Discussion Regarding Proposed Change of BHA Covenants to Allow Construction of Access 16

Village Proposal: New High-Volume Beach Access 16

Proposed Access 16 overlaid on Google Earth to the correct proportions.

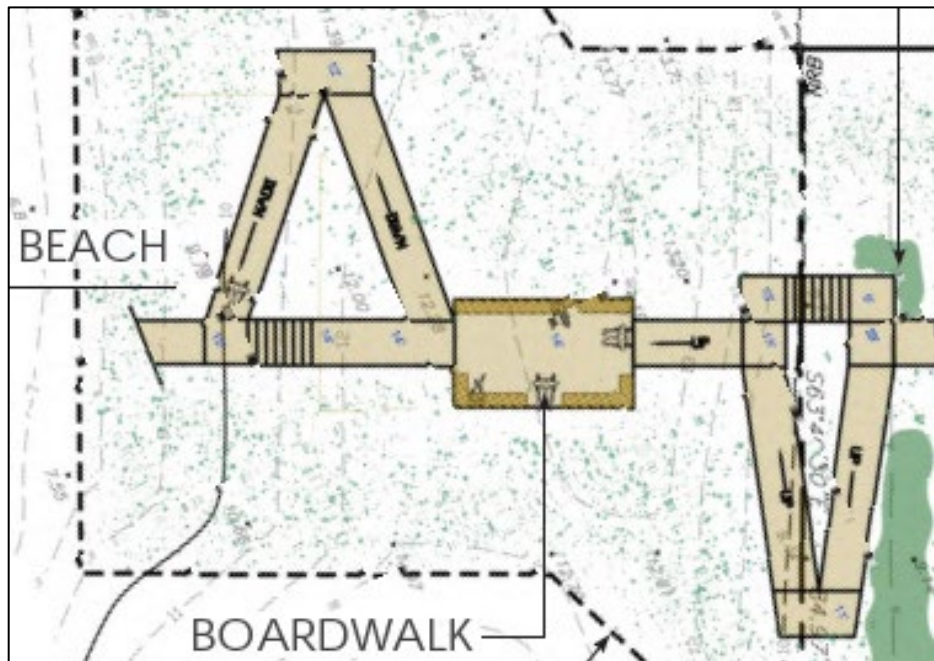
Why build a new access directly adjacent to two existing public access points?

- Why would the island need a new public beach access right between two existing access points?
- Access 17 is 200 feet away and Access 15 is 500 feet away.
- Clearly there are other objectives at play rather than just increasing the inventory beach access points for fishing, shell hunting, and building of sandcastles. Is the need for this new access truly driven by the need to provide for ADA Access or are other motivations at play? Other possible objectives of this project include:
 - Create a high-visibility observation platform and tourist attraction for day-trippers
 - Create a high-volume parking lot to relieve parking constraints
- Has the desire to build a high-volume beach access along South Beach superseded the original objective of providing ADA access?
- Given the steep nature of the 14-foot dunes at this location, this site is a poor choice for ADA access.

Have special needs stakeholders and their caregivers been consulted about the difficulty of choosing a location that requires 4 ramps and 2 switchbacks?

Illustration Provided by Village Minimizes the Visual Impact:

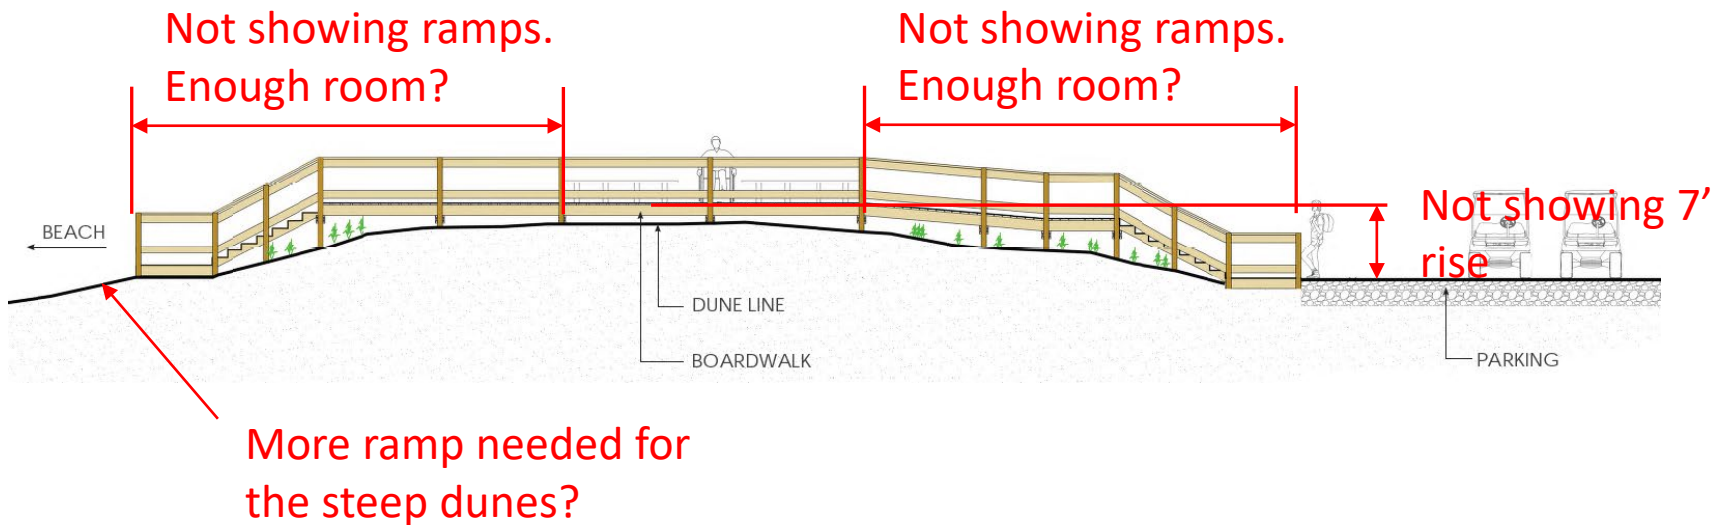
- Minimum 7-foot rise from parking to platform not depicted
- No ADA ramps shown in this illustration (ADA access should be the primary objective)
- Depiction minimizes the height of the observation platform
- Parking surface at 9 feet elevation and dune peak at 14 feet elevation makes 5 feet in rise
- This design criteria will place the observation deck at 16 feet in elevation – nearly two stories high
- Design parameters put the rise at 7 feet without consideration for scraping of the parking lot which will likely lower the starting point to below 9 feet in elevation thus increasing the overall rise to greater than 7 feet.

Image dated June 14, 2019 – status of dune repair following Hurricane Florence storm surge in August 2018. Location of ramps to be built directly over repaired dunes. Proposed parking lot surface area to increase the risk of accelerated water flow in a surge event.

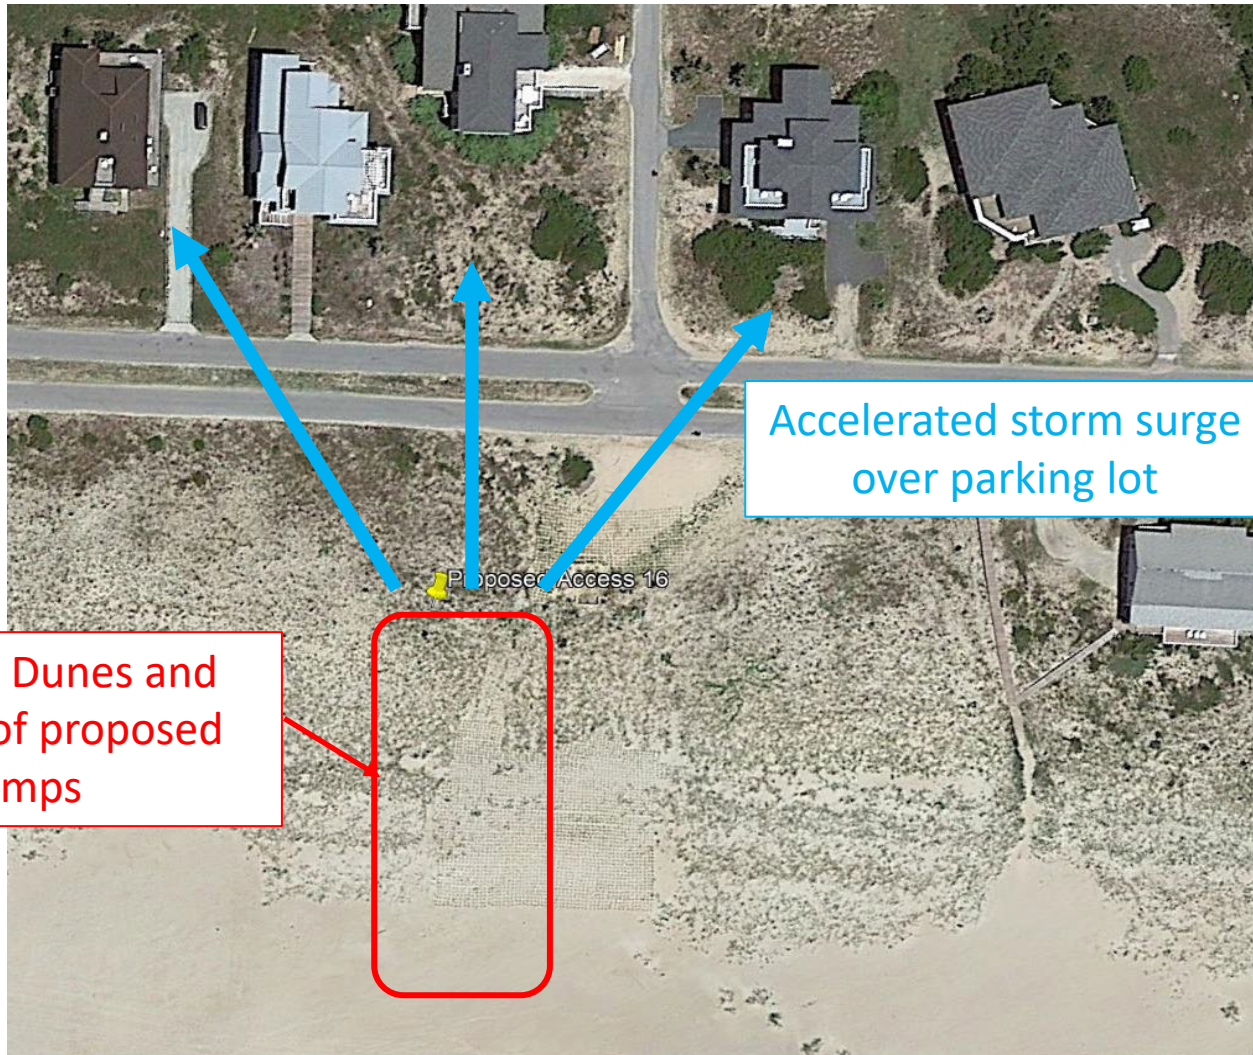
Image dated June 14, 2019 – status of dune repair following Hurricane Florence storm surge in August 2018. Location of ramps to be built directly over repaired dunes. Proposed parking lot surface area to increase the risk of accelerated water flow in a surge event.

Alternate Option 1: Pursue original plan at existing Access 15

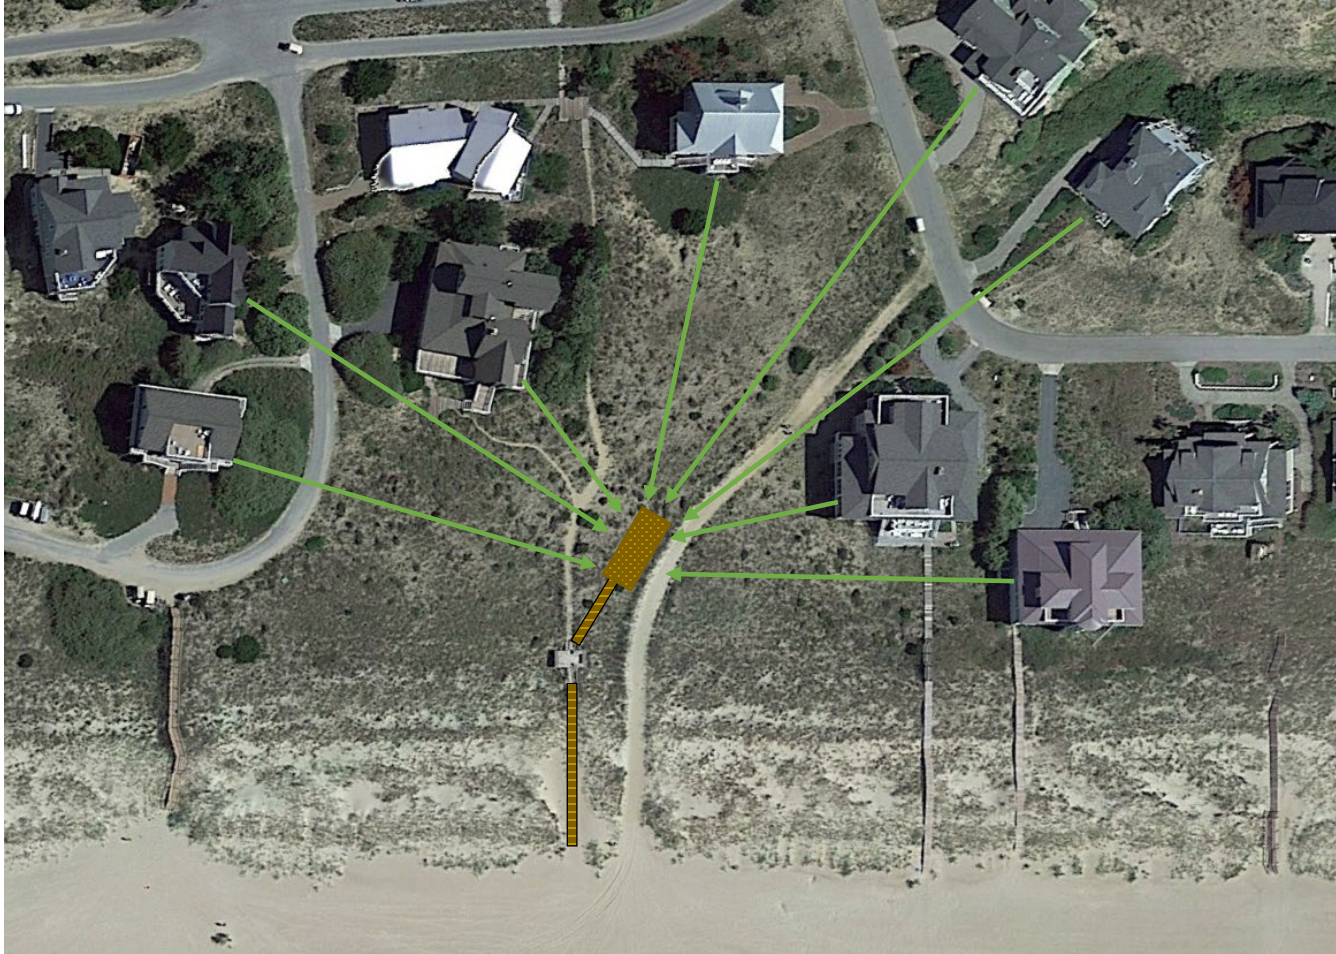
- Upfit existing boardwalk to gently sloping ADA compliant ramp.
- Add general parking along SBHW in existing municipal easement.
- Convert existing parking to ADA pass holders.
- Utilizes existing infrastructure and creates essentially no change to the visual and environmental impact.

7 homes with minimally modified views of existing Access 15

Alternate Option 2b: Enhance existing Access 24b

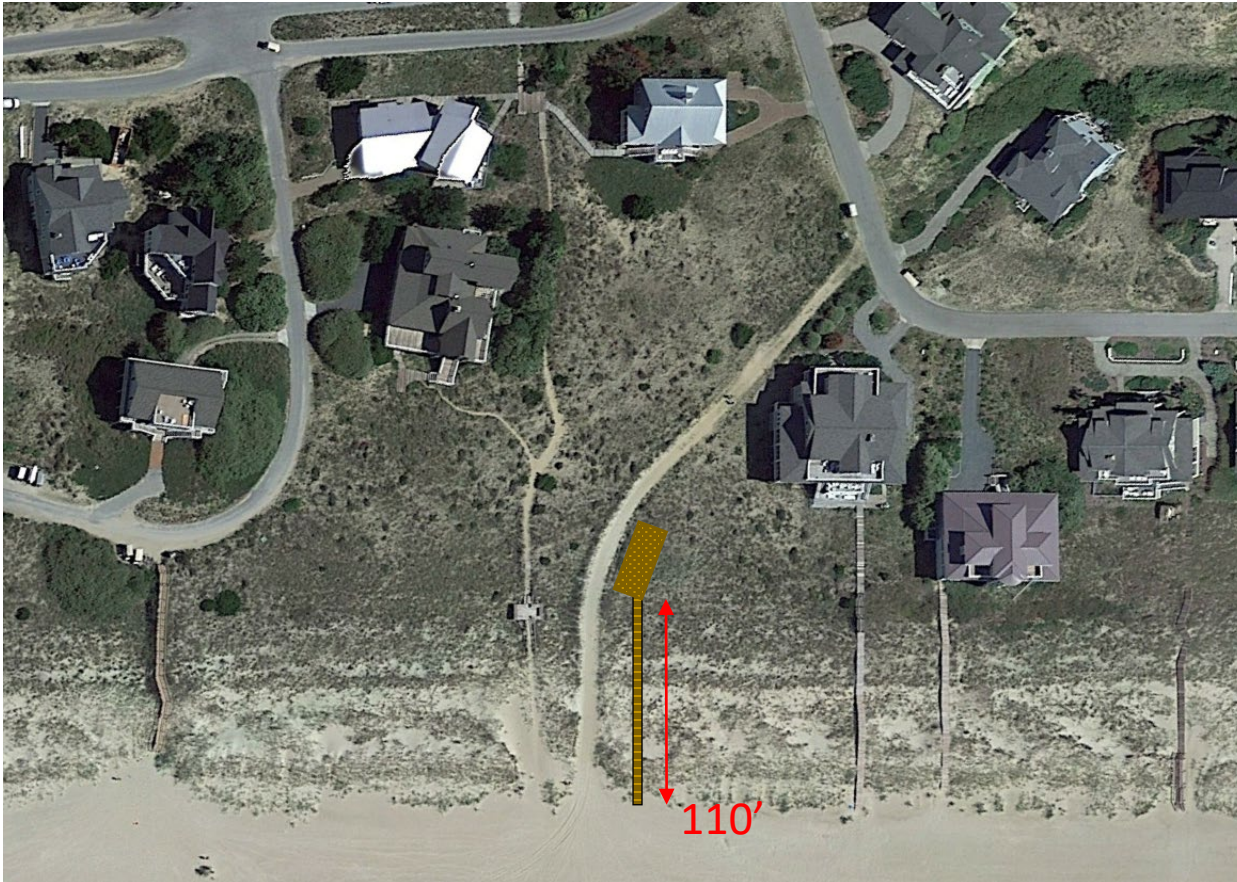
- Utilize entrance to existing Access 24b.
- Create new small parking lot only for ADA pass holders.
- Connect into existing boardwalk for Access 24a and build ADA compliant ramp to cross 4-foot dune.

8 homes with minimally modified views of existing Access 24a and 24b

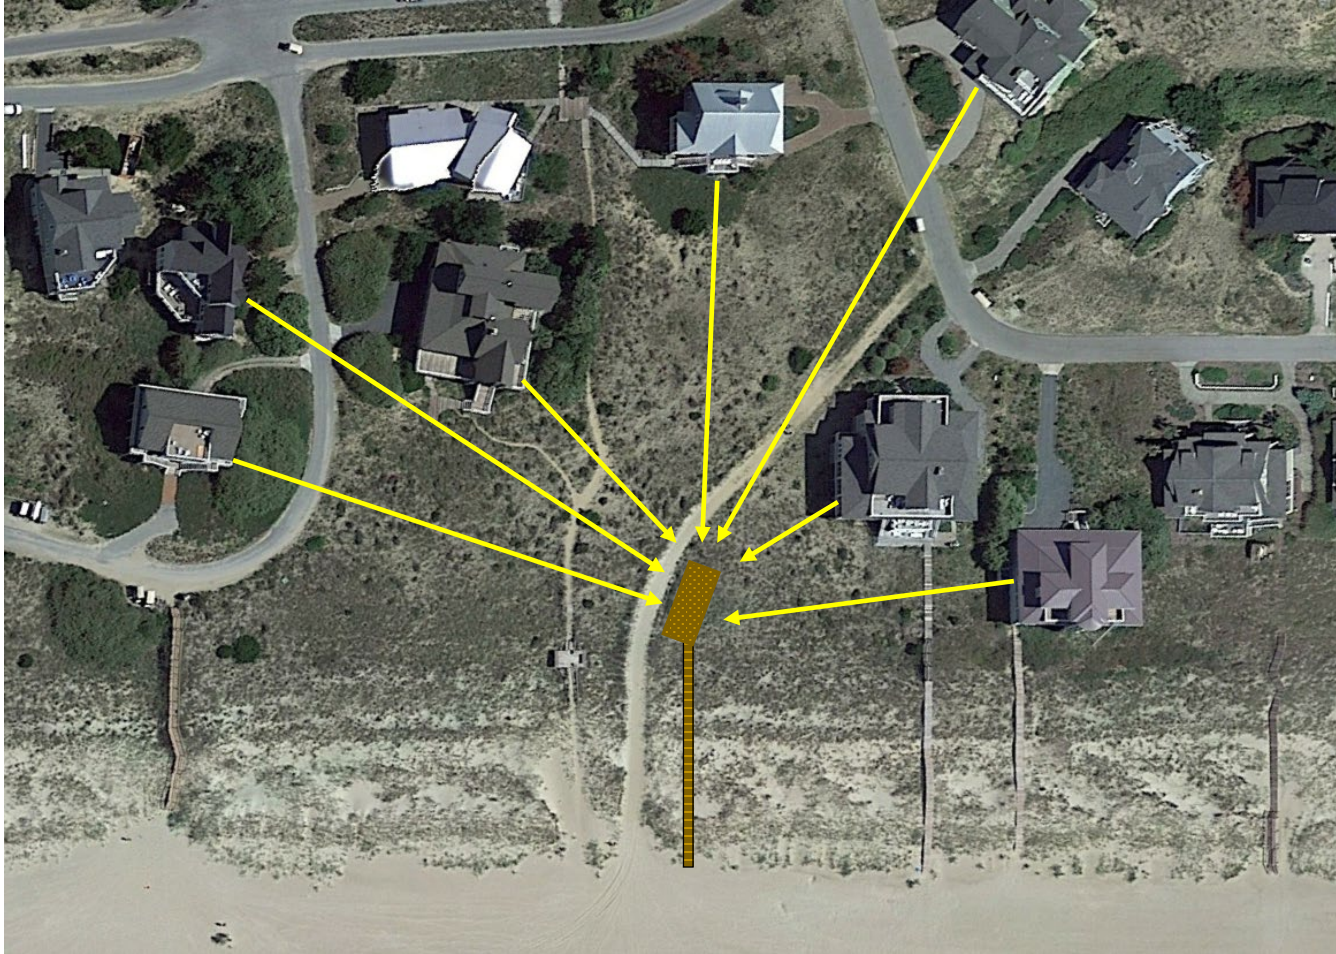
- Utilize entrance to existing Access 24b
- Create new small parking lot only for ADA pass holders.
- Build new gently sloping ADA compliant ramp over 4-foot dunes.
- This is essentially the same concept as is currently proposed by the Village, but at a location with less visual impact and much lower dunes.

7 homes with minimally modified views of existing Access 24b
